**WRITTEN STATEMENT OF CONDITIONS**

The City of North Richland Hills received this plat on April 5, 2024. The Development Review Committee reviewed this plat on April 16, 2024. The following represents the written statement of the conditions for conditional approval of the plat. The applicant may submit a written response and revised plat that adequately addresses each condition.

BEING  
 AN ADDITION TO THE CITY OF NORTH RICHLAND HILLS  
 1.47 ACRES IN THE  
 T. MARTIN SURVEY, ABSTRACT No. 1055  
 SITUATED IN THE  
 CITY OF NORTH RICHLAND HILLS, TARRANT COUNTY, TEXAS  
 FEBRUARY 2024

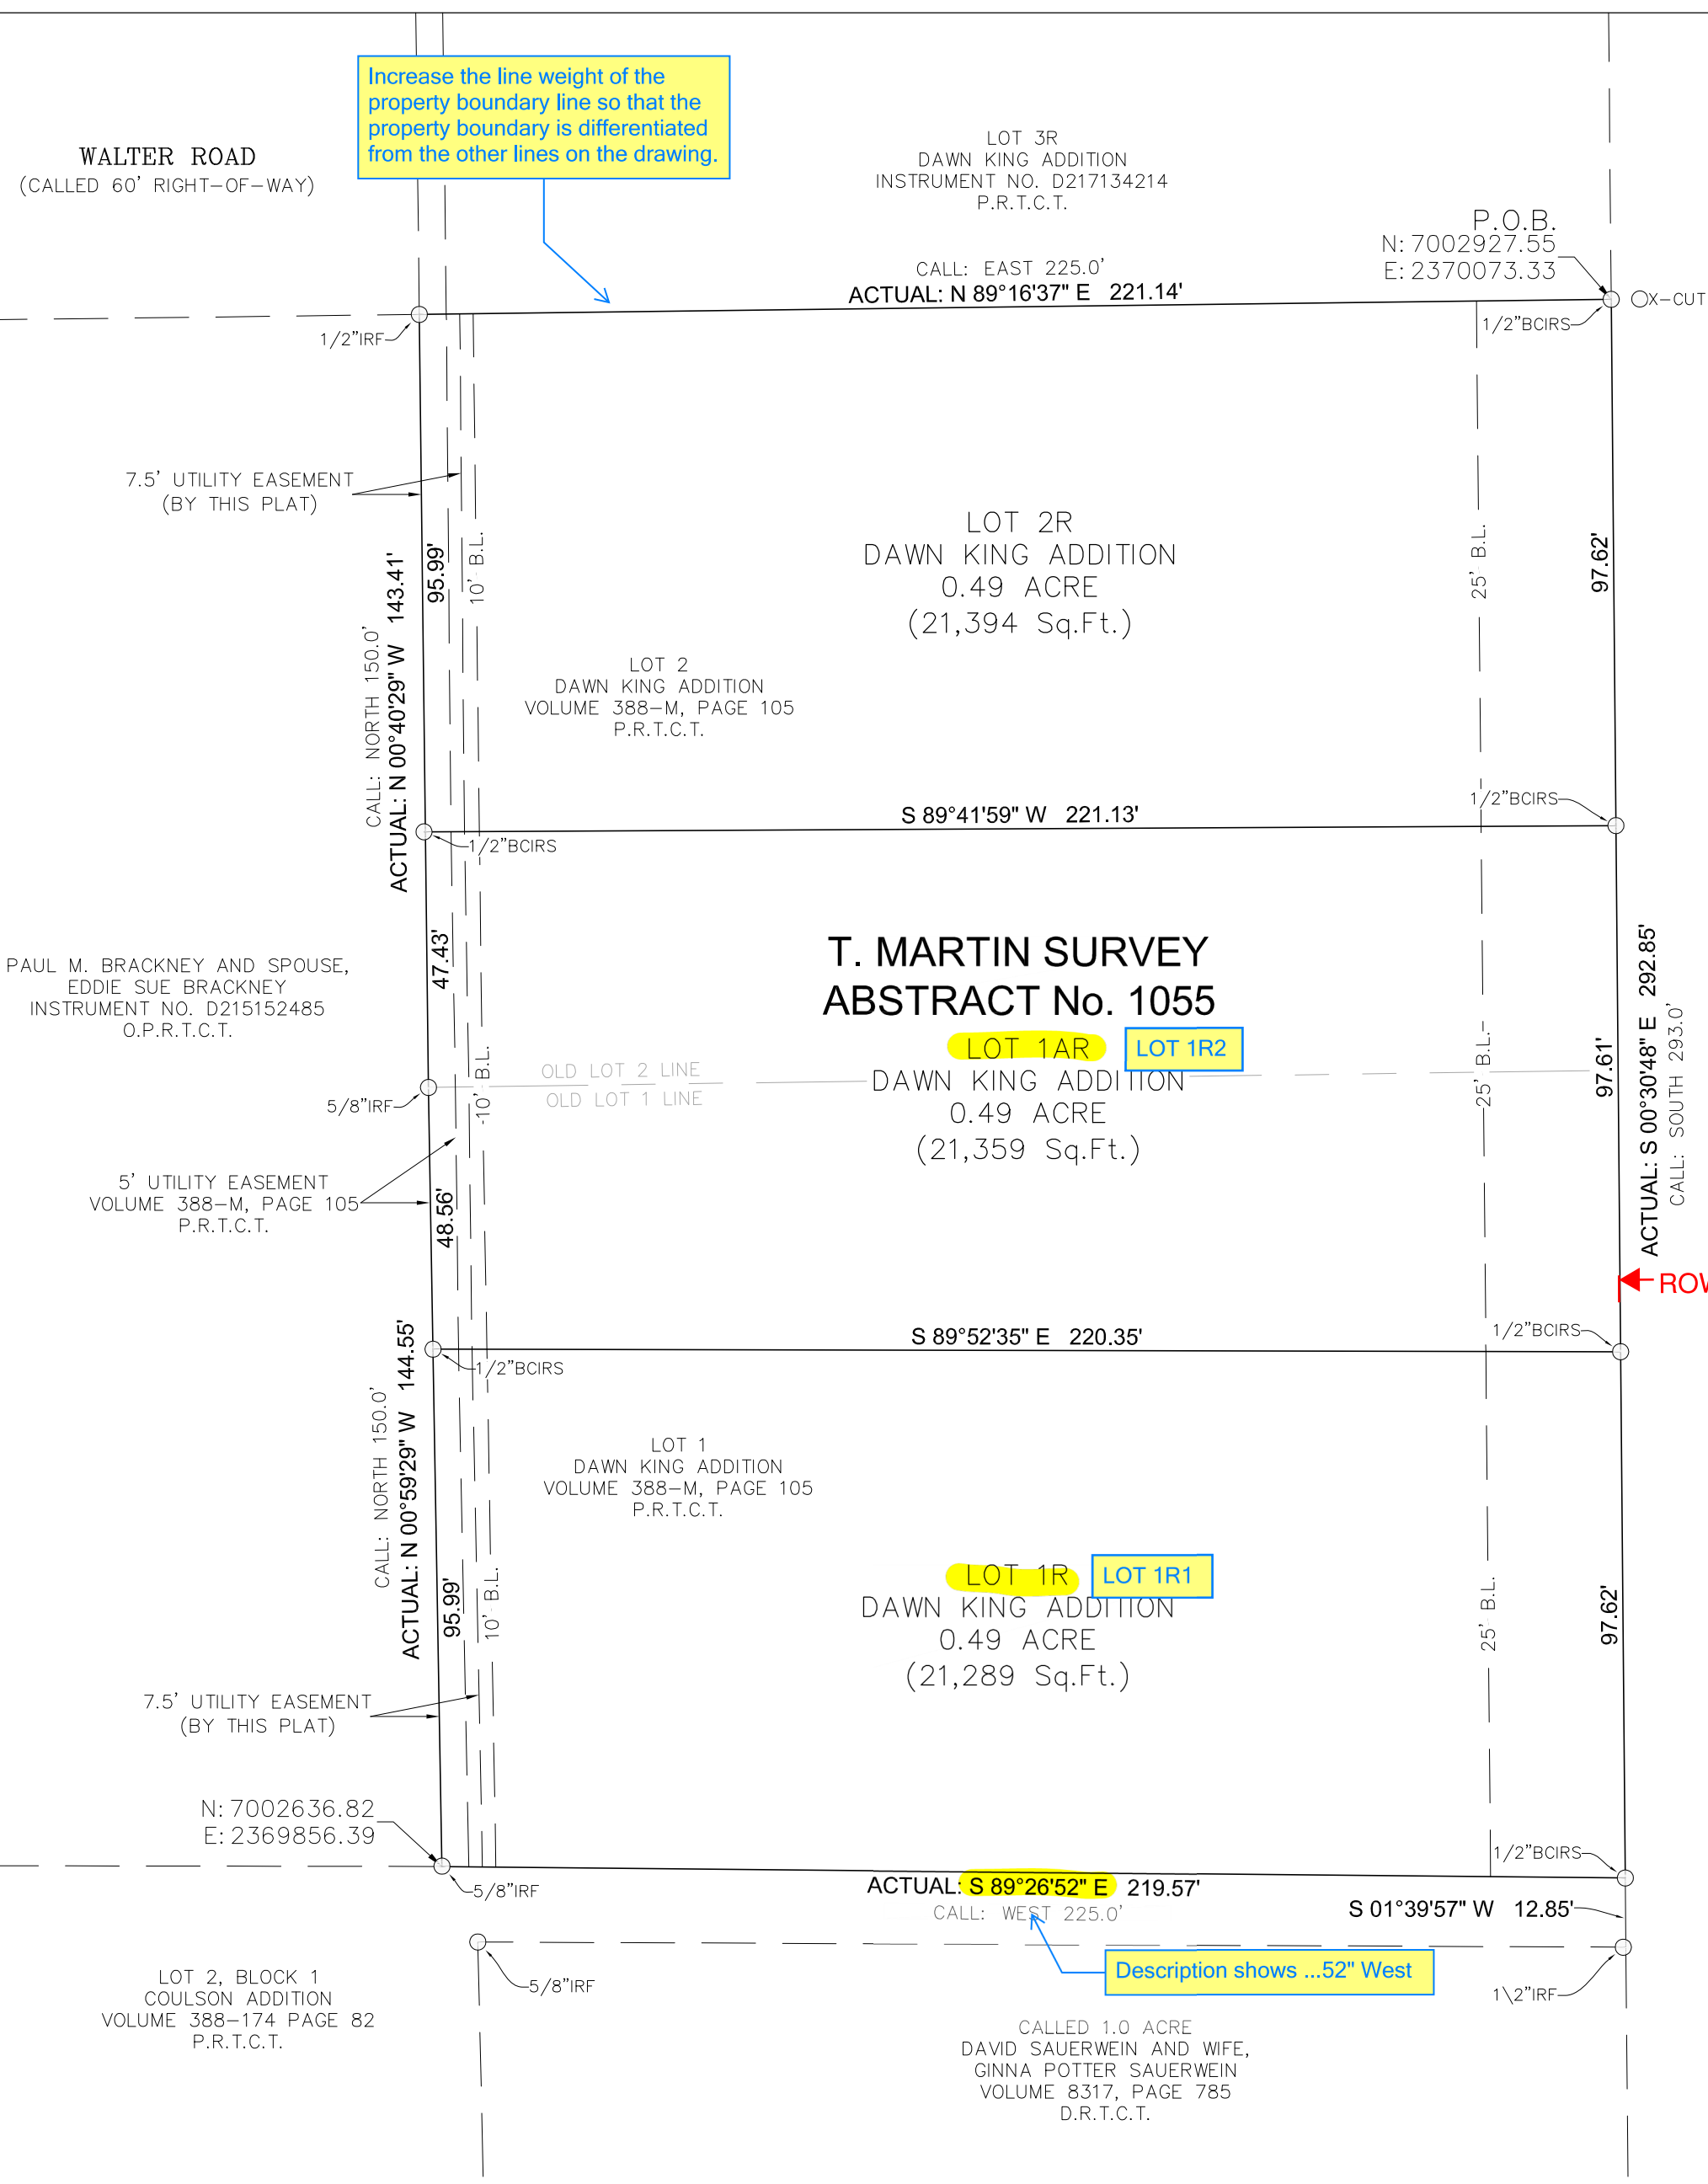
1. **Informational.** A zoning change application was submitted for this property in conjunction with the subdivision plat. The review of the plat was based in part on proposed zoning of R-1 (Single-Family Residential). *NRH Subdivision Regulations §110-384 (Conformity with zoning regulations)*

2. Update the title block to read **REPLAT** rather than **PLAT REVISION**. *NRH Subdivision Regulations §110-331 (Requirements for all plat drawings –title block)*

3. There are minor revisions and corrections required in the owner’s certificate, and these are noted on the marked-up copy of the plat. These should be updated as appropriate. *NRH Subdivision Regulations §110-331 (Requirements for all plat drawings – metes and bounds description)*

4. Increase the line weight of the property boundary line so that the property boundary is differentiated from the other lines in the drawing. *NRH Subdivision Regulations §110-331 (Requirements for all plat drawings – subdivision boundary)*

5. Change the lot designations to Lots 1R1, 1R2, and 2R on the drawing, the title block, and other relevant instances. *NRH Subdivision Regulations §110-331 (Requirements for all plat drawings – lot and block numbering)*

6. The County clerk recording block may be removed from the drawing. Plats are recorded electronically, and the block is not necessary. *NRH Subdivision Regulations §110-333 (Additional requirements for plat drawings – county certification)*

7. Crane Road is classified as a C2U Minor Collector on the Transportation Plan. An R2U roadway requires an ultimate right-of-way of sixty (60) feet. Verify the existing right-of-way with established corner monuments on the opposite side of the street. Right-of-way dedication would be required to establish thirty (30) feet of right-of-way measured from the centerline of the existing right-of-way. *NRH Subdivision Regulations §110-368 (Street right-of-way dedication) and §110-412 (Generally – rights-of-way)*

8. Remove the 10-foot rear building line on the lots. It is not necessary to show this building line as it is regulated by the zoning of the property. *NRH Subdivision Regulations §110-331 (Requirements for all plat drawings – building setback lines)*

9. Add the following notes to the plat. *NRH Subdivision Regulations §110-331 (Requirements for all plat drawings – plat notes and conditions):*
  - a. This plat does not remove any existing covenants or restrictions, if any, on the property.

- b. Above ground franchise utility appurtenances are not allowed in the fronts of the properties.
  - c. The easements indicated on this plat are for the purpose of constructing, using, and maintaining public utilities including underground conduits, manholes, pipes, valves, posts, above ground cables, wires, or combinations thereof, together with the right of ingress and egress to operate and maintain the public utilities.

10. Show the property lines and plat recording or deed information of the lots that are within 100 feet of this property on the east side of Crane Road. *NRH Subdivision Regulations §110-331 (Requirements for all plat drawings – adjacent properties)*

Add the following notes to the plat:

- This plat does not remove any existing covenants or restrictions, if any, on the property.
- No above ground franchise utility appurtenances are allowed in the fronts of the properties.
- The easements indicated on this plat are for the purpose of constructing, using, and maintaining public utilities including underground conduits, manholes, pipes, valves, posts, above ground cables, wires, or combinations thereof, together with the right of ingress and egress to operate and maintain the public utilities.

PLAT REVISION ← REPLAT

LOTS 1R1, 1R2, AND 2R → LOTS 1R, 1AR, AND 2R
